# UNITED STATES PATENT AND TRADEMARK OFFICE

APPLICATION NO.	FILING DATE	FIRST NAMED INVENTOR	ATTORNEY DOCKET NO.	CONFIRMATION NO.
10/589,929	08/20/2007	Holger Bauer	2003P15370WOUS	3756

<b>Office Action Summary</b>	<b>Application No.</b> 10/589,929	<b>Applicant(s)</b> BAUER ET AL.	
	<b>Examiner</b> PHUTTHIWAT WONGWIAN	<b>Art Unit</b> 3741

## DETAILED ACTION

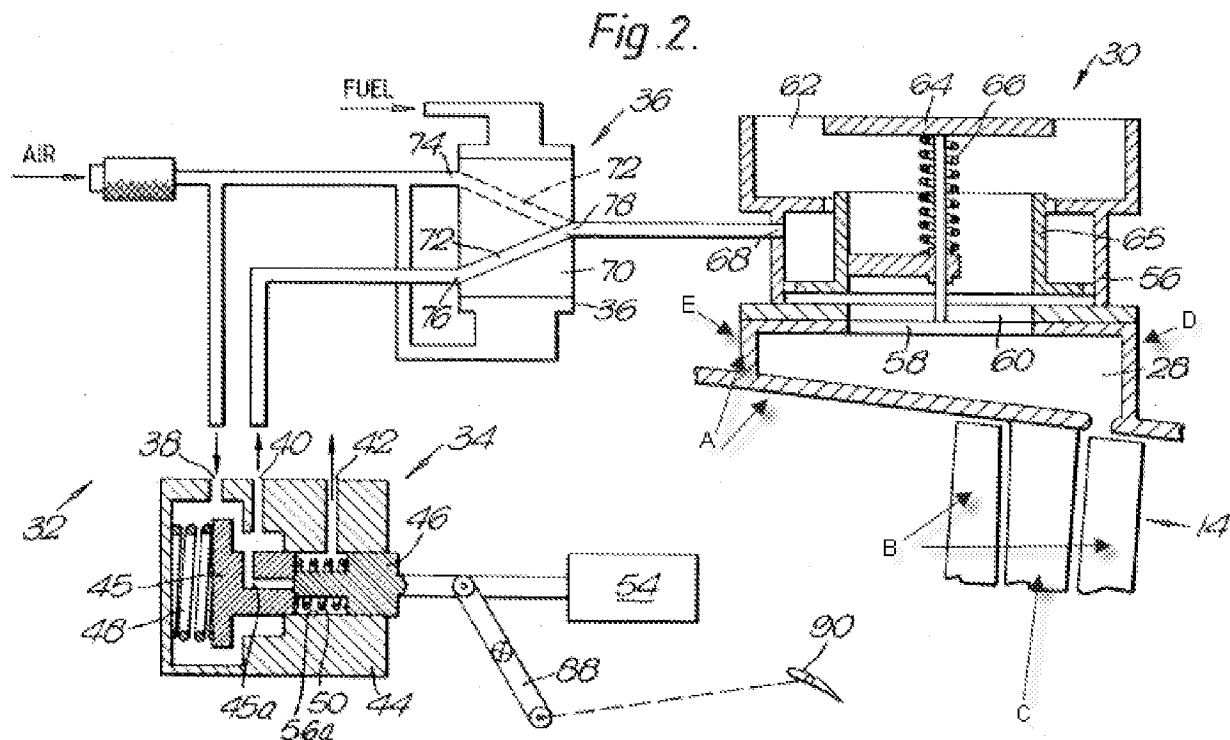
11. As to claim 9, Cureton discloses a gas turbine having a compressor 14 (fig. 2), comprising: a compressor housing A (fig. 2 above) coaxially surrounding the compressor; a cavity 28 (fig. 2) in the housing configured to thermally influence (fig. 2 above) the housing, and a tap line 62 (fig. 2) in flow communication with the cavity for [intended use] extracting a portion of a compressed fluid flow of the compressor; and a locking device 30 (fig. 2) arranged in line with the tap line and downstream of the cavity that locks off the extracted compressed flow through the tap line (fig. 2).

12. As to claim 14, Cureton discloses an axial flow compressor 14 (fig. 1) configured for [intended use] operation with a gas turbine engine, comprising: a compressor rotor 20 (fig. 1) arranged along an axis of the compressor; a plurality of compressor blades B (fig. 2 above) arranged on the rotor in axial stages; a compressor housing A (fig. 2

above) coaxially surrounding the rotor; a cavity 28 (fig. 2) in the housing configured to thermally insulate (fig. 2) the housing, and a tap line 62 (fig. 2) in flow communication with the cavity 28 (fig. 2) for [intended use] extracting a portion of a compressed fluid flow of the compressor; and a plurality of stationary compressor blades C (fig. 2) secured to the housing arranged in axial stages (fig. 1); a locking element 30 (fig. 2) arranged in the tap line downstream of the cavity to block off the flow of removed air (fig. 2).

13. As to claims 10, 15, 18-22, Cureton discloses the cavity 28 (fig. 2) extends downstream from the tap 62 (fig. 2), within the housing, over at least two rows of the compressor blades B (fig. 2 above), wherein the cavity is radially larger at a downstream end D (fig. 2 above) thereof than at an upstream end E (fig. 2 above) thereof and wherein the valve is open during operation of the gas turbine (fig. 2 above), and is closed or partially closed during a shutdown of the gas turbine (inherent).
